## NOTICE OF HEARING BOARD MEETING LOWER TRENT CONSERVATION

O. Reg. 41/24 Permit Application #RP-24-232

## STAFF REPORT

**Date:** February 28, 2025  
**To:** Lower Trent Conservation Hearing Board  
**Re:** Ontario Regulation 41/24 application for permission RP-24-232 to develop within the Butler and Arena Creek floodplain and within 30-metres from a wetland feature  
**Prepared by:** Gage Comeau, Manager, Watershed Management, Planning and Regulations

Water Surface Elevation on 'Profile Line: House of Interest'

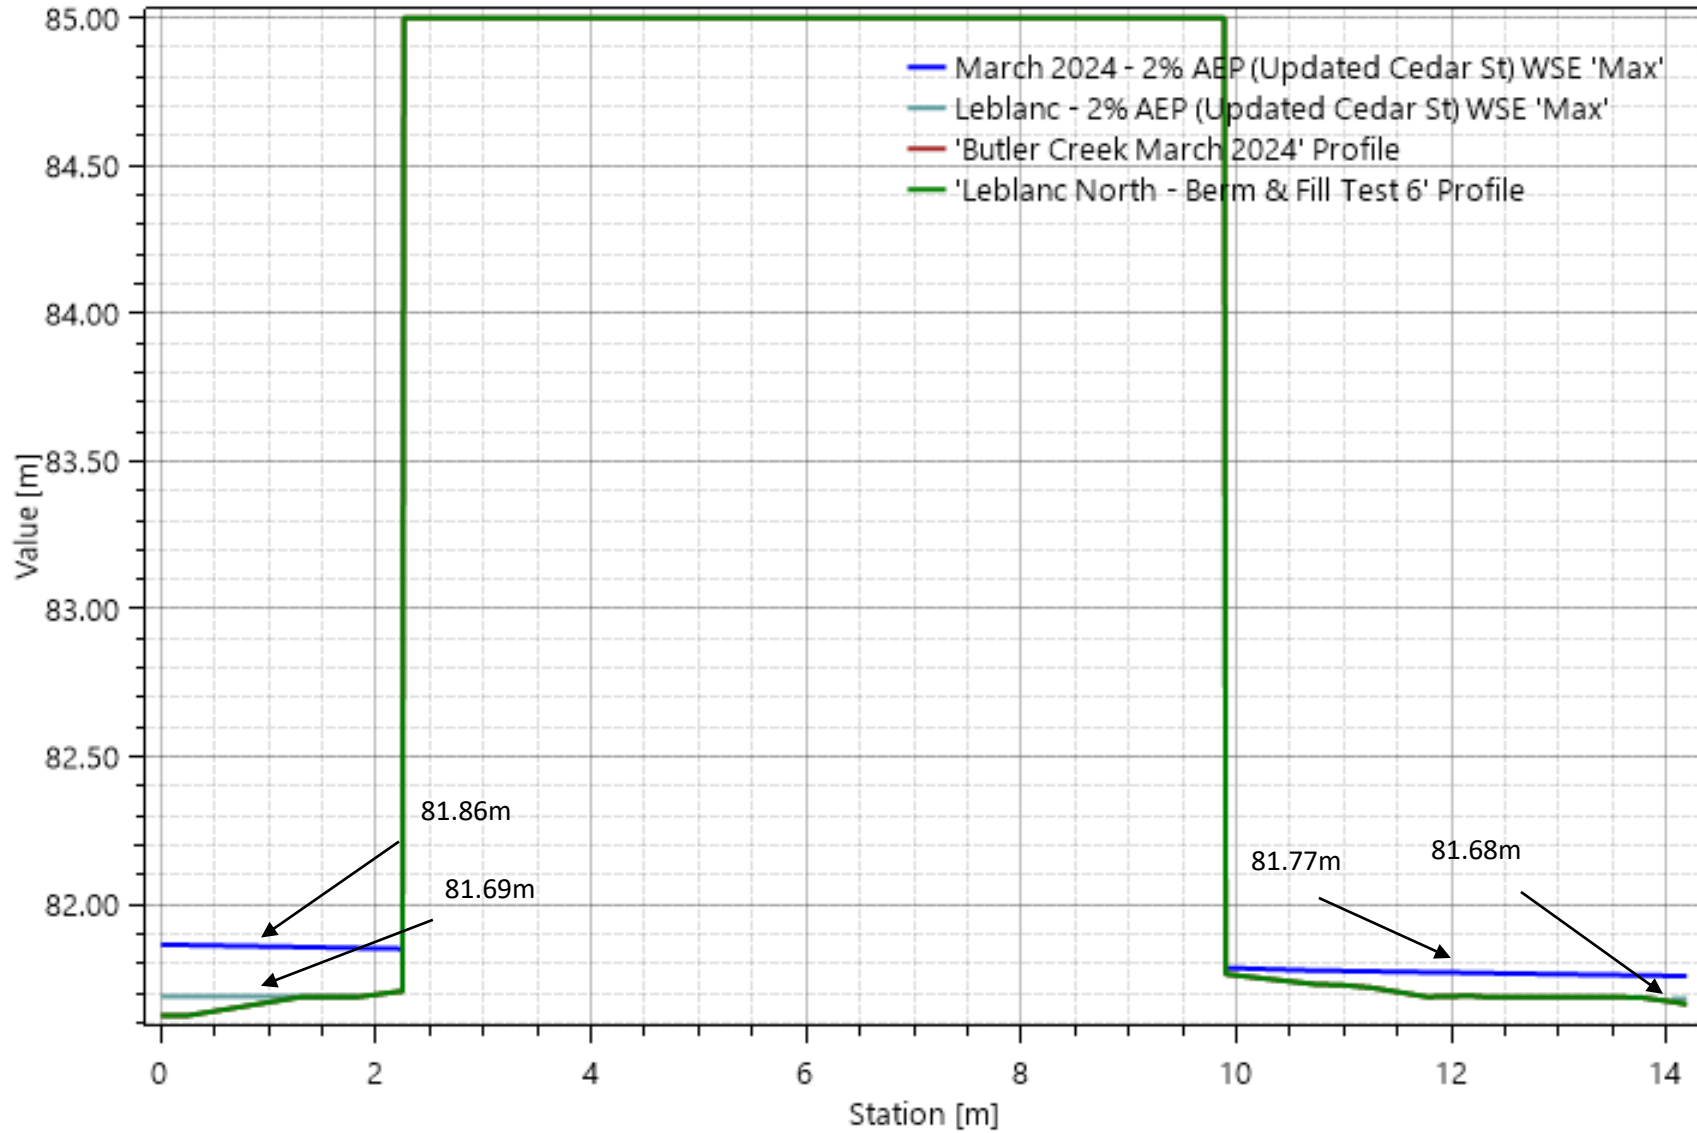
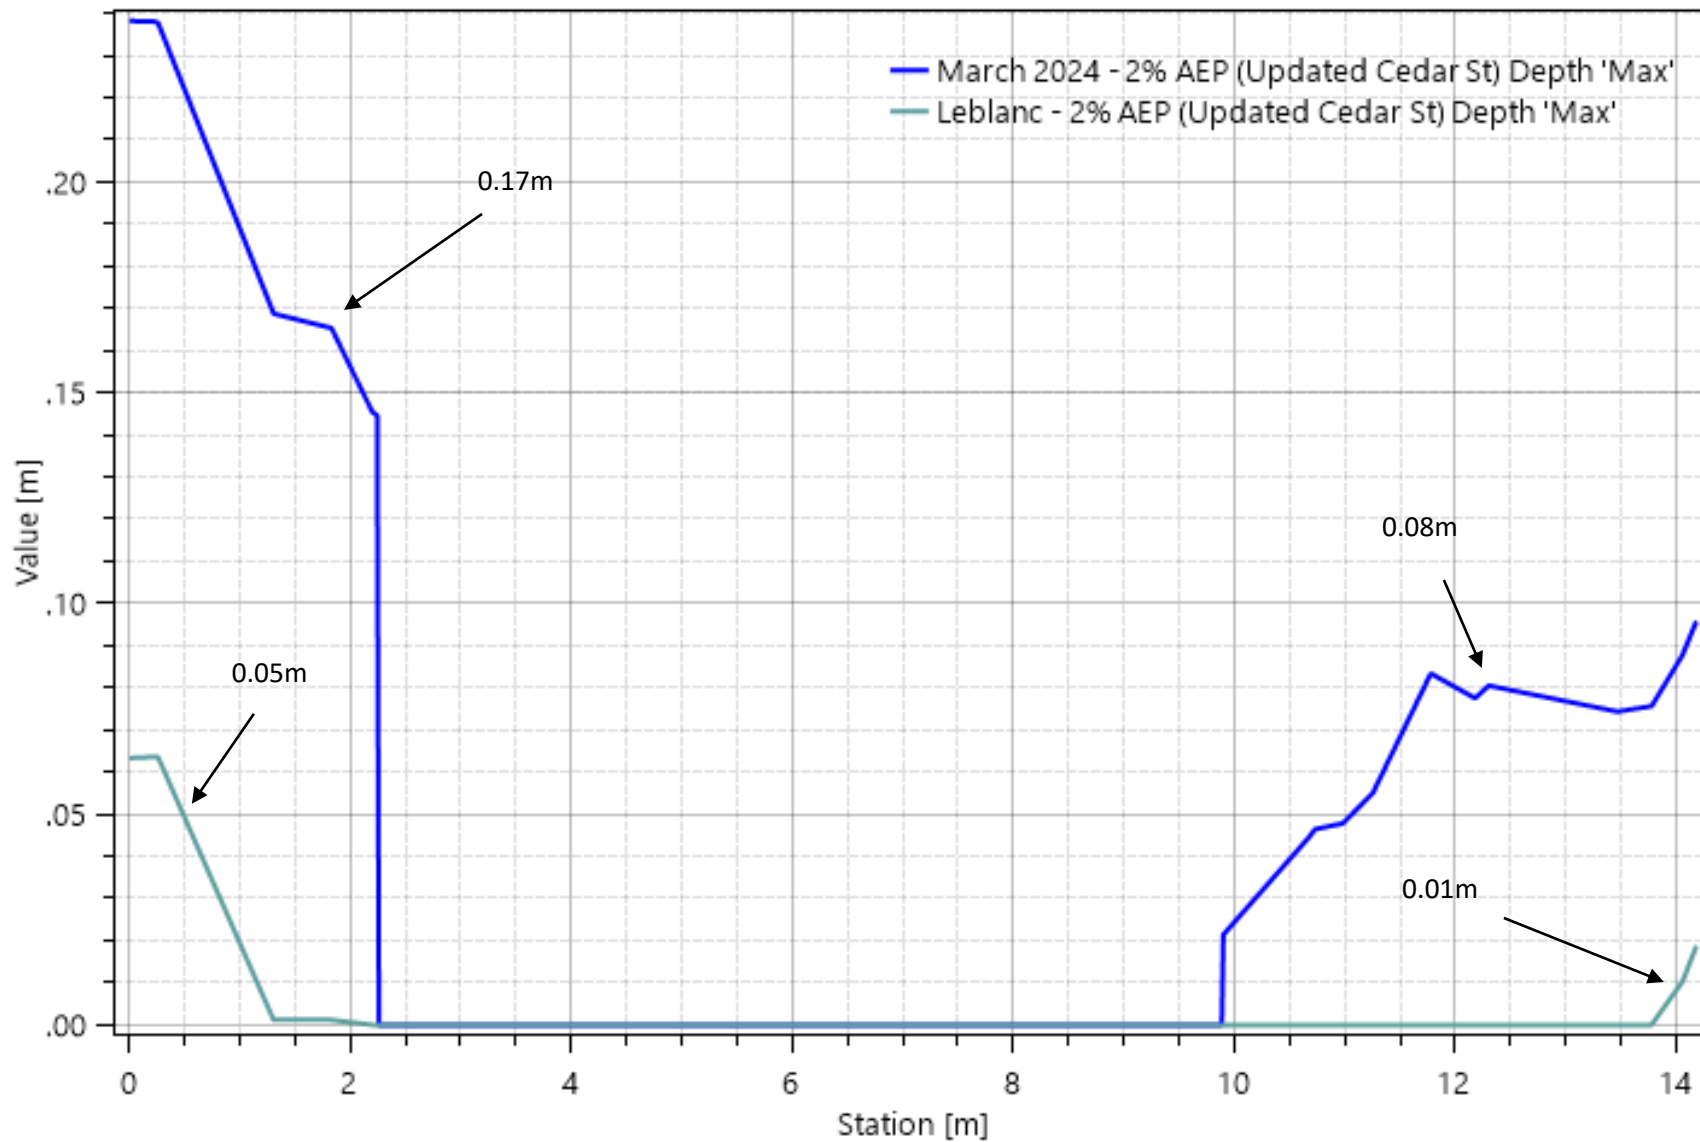
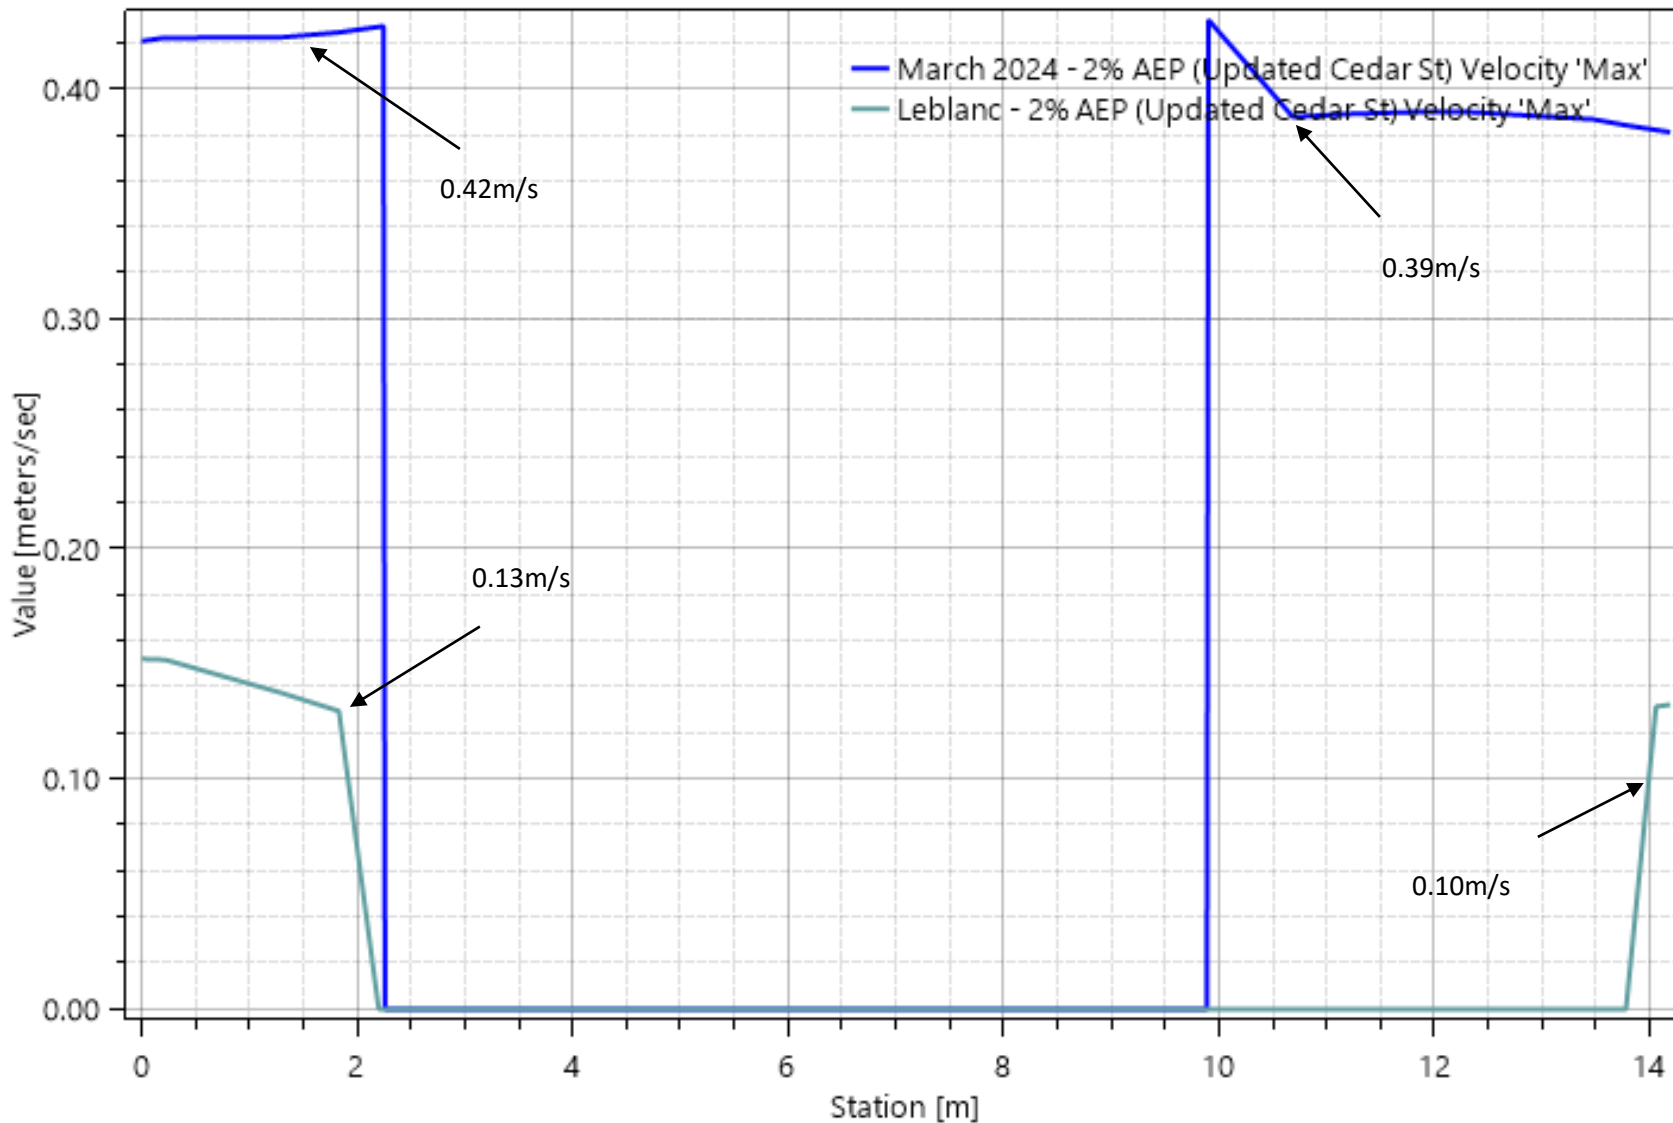
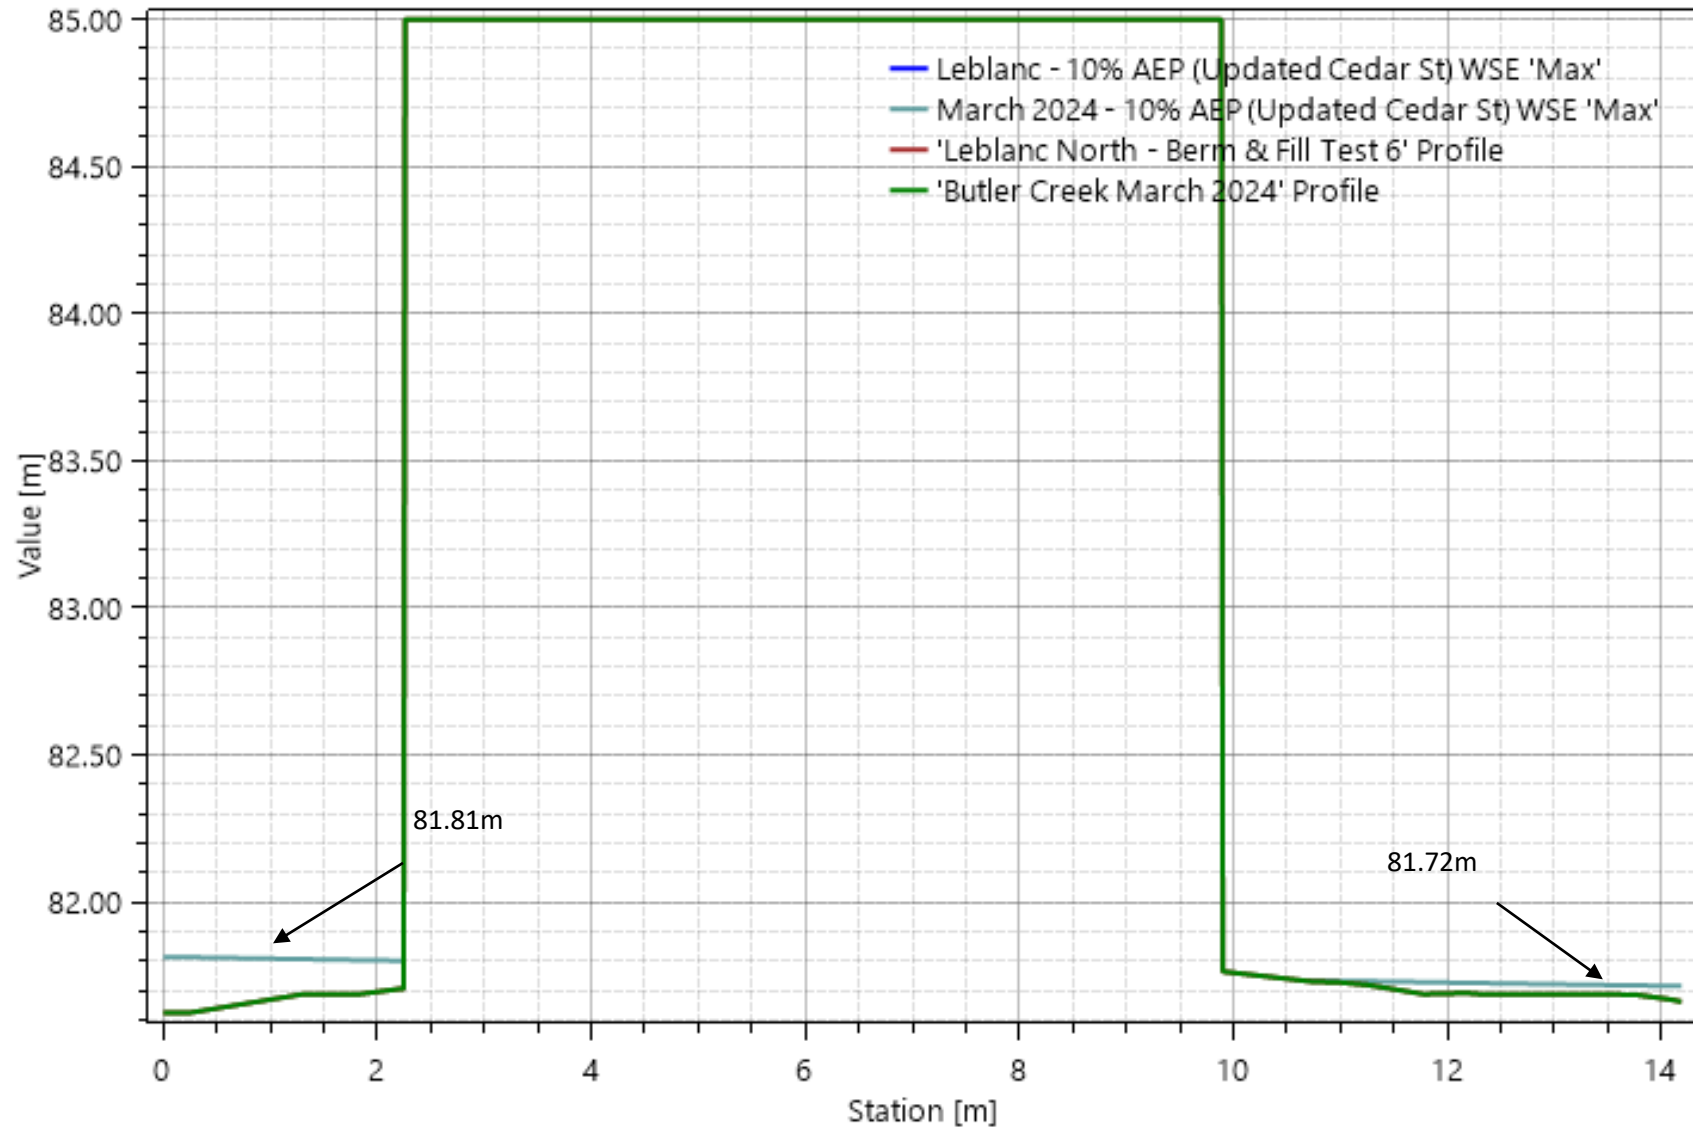
<b>Request #1:</b>	<p>The depth and velocity information before and after the flood mitigation plan at the house immediately upstream of Cedar Street.</p> <p>An assessment of smaller return period events was noted to be useful to confirm whether the house is negatively affected in events less than the regulatory storm.</p>
